Subject: **GAMMA MODIFICATION**

Model: ***BVM-D24E1WE***, **BVM-D24E1WU**
BVM-D32E1WE, **BVM-D32E1WU**

Serial No: **2,000,001 AND HIGHER**

Figure 1

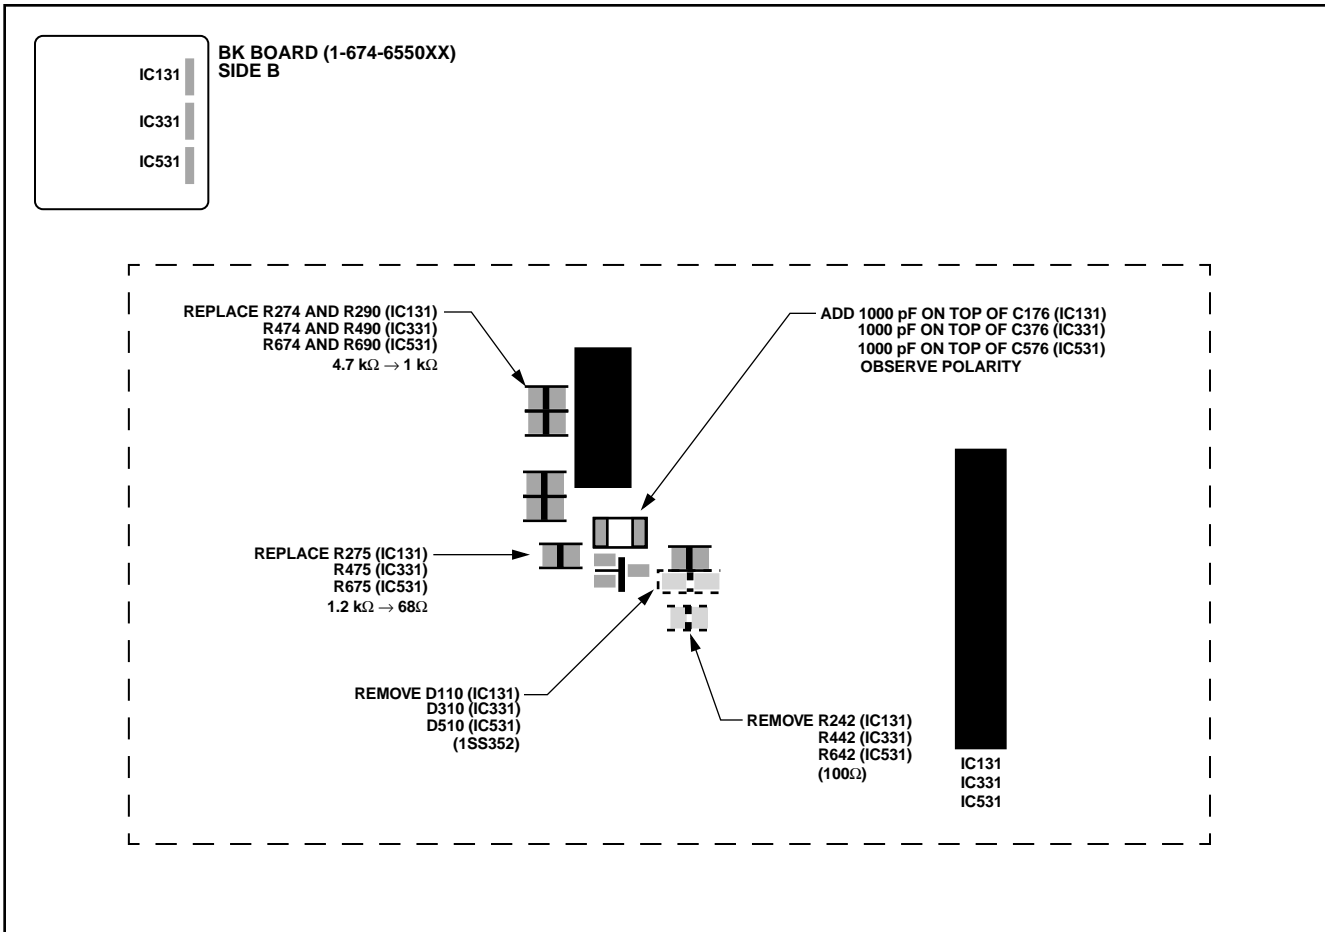
1. Replace R274, R474, and R674 (4.7 kΩ) with 1 kΩ chip resistors.
2. Replace R275, R475, and R675 (1.2 kΩ) with 68Ω chip resistors.
3. Replace R290, R490, and R690 (4.7 kΩ) with 1 kΩ chip resistors.
4. Remove 100Ω chip resistors R242, R442, and R642.
5. Remove diodes D110, D310, and D510 (1SS352).

Figure 2

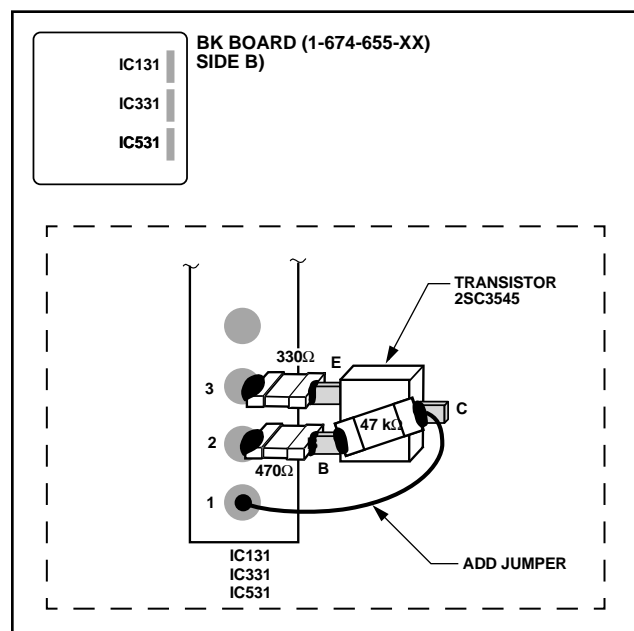
6. Solder one lead of 330Ω chip resistor vertically to IC131 pin 3.
7. Solder one lead of 470Ω chip resistor vertically to IC131 pin 2.
8. Position new 2SC3545 transistor with I.D. number facing down, and solder:
 - Emitter to remaining lead of 330Ω resistor
 - Base to remaining lead of 470Ω resistor
9. Solder new 47 kΩ resistor between collector and base of new transistor.
10. Repeat steps 6 through 9 for IC331 and IC531.
11. Solder three new 10 mm jumpers (AWG28), respectively, between the Collector of each of the three transistors added in step 8 and :
 - IC131 pin 1
 - IC331 pin 1
 - IC531 pin 1

Figure 3

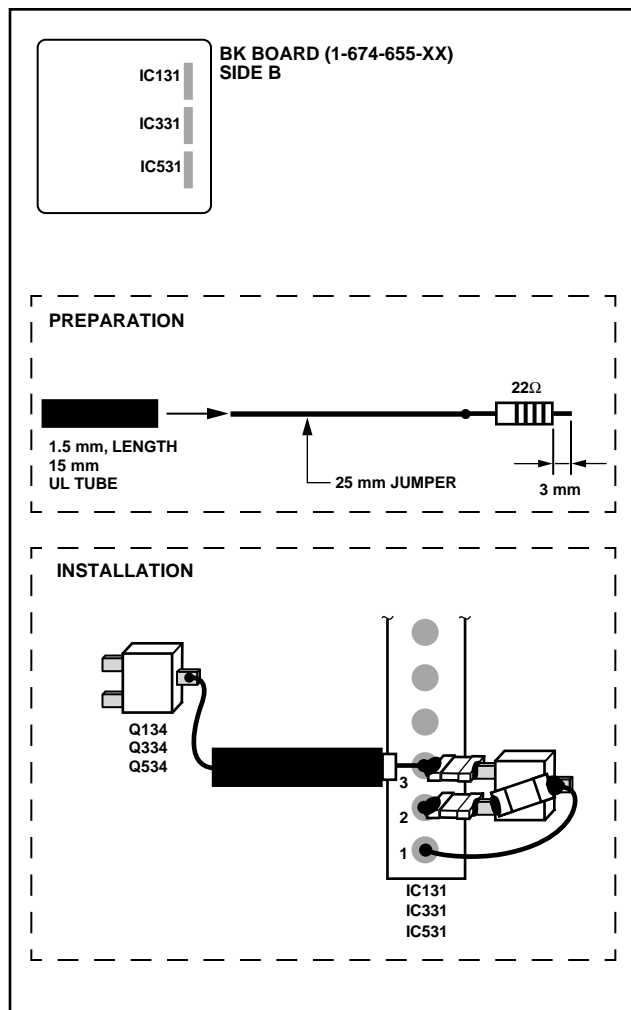
12. Prepare three resistor/jumper combinations:
 - a. Shorten one lead of 22Ω resistor to 3mm
 - b. Solder 25 mm jumper (28AWG) to other lead of 22Ω resistor.
 - c. Cover resistor/jumper combination with 15 mm insulation tube (1.5 mm diameter).

13. Solder free end of jumper to collector of Q134.
14. Solder other resistor lead to IC131 pin 3.
15. Thread UL tubing to cover solder point at pin 3.
16. Repeat installation steps 13, 14, and 15 for Q334/IC331 and Q534/IC531, respectively.

Figure 4

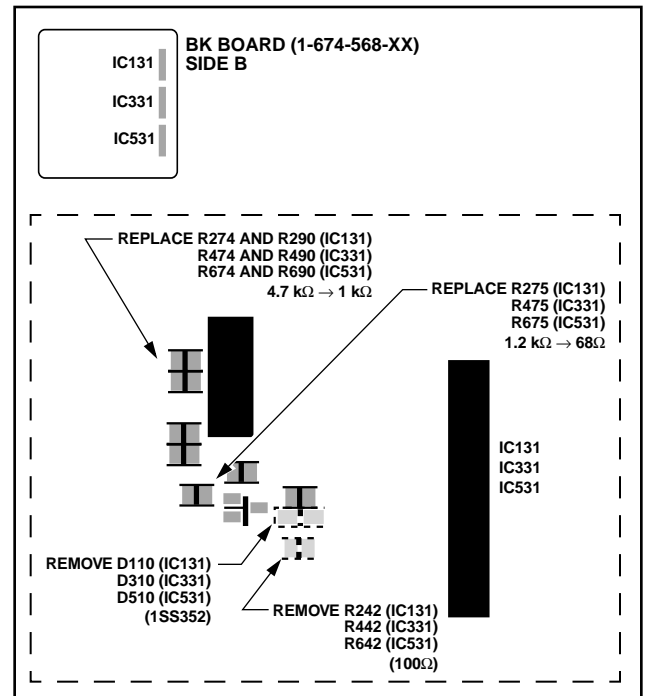
1. Replace R274, R474, and R674 (4.7 kΩ) with 1 kΩ chip resistors.
2. Replace R275, R475, and R675 (1.2 kΩ) with 68Ω chip resistors.
3. Replace R290, R490, and R690 (4.7 kΩ) with 1 kΩ chip resistors.
4. Remove 100Ω chip resistors R242, R442 and R642.
5. Remove diodes D110, D310 and D510 (1SS352).
6. Solder new 22Ω chip resistors to R298, R498, and R698.
7. Solder new 330Ω chip resistors to R297, R497, and R697.
8. Solder new transistors, with I.D. number facing up, to Q190, Q390, and Q590.
